Product Change Notification MultiMark terminal Marker

PCN-PI80-20170918-01-ODMM

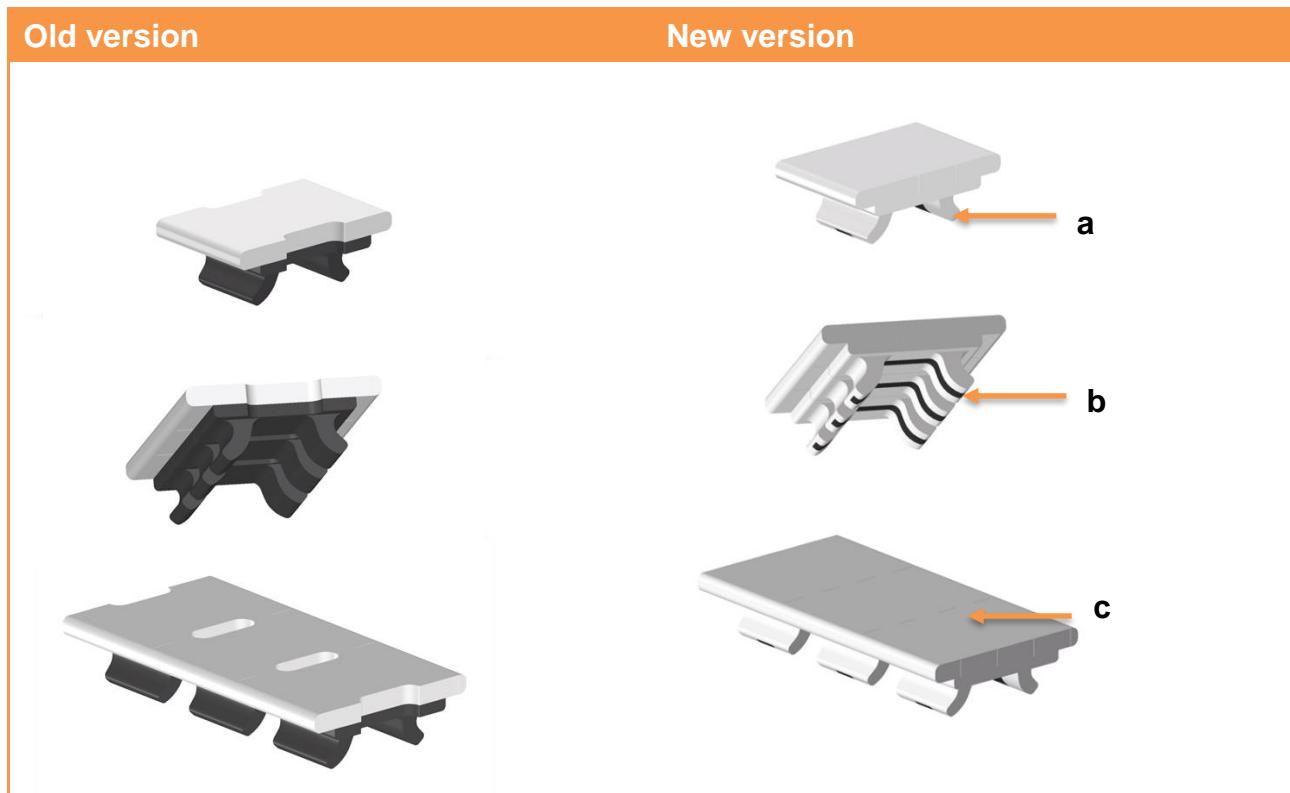
- The rear side of the material will be white(a).
- A black mark, also on the rear side, acts as the reference for the sensor in the printer
- The top side has a continuous white surface(c) without a sensor gap

The old print roller fed the material via friction through its rubber surface. The new print roller engages with the terminal marker via a sprocket wheel, ensuring a strong mechanical connection.
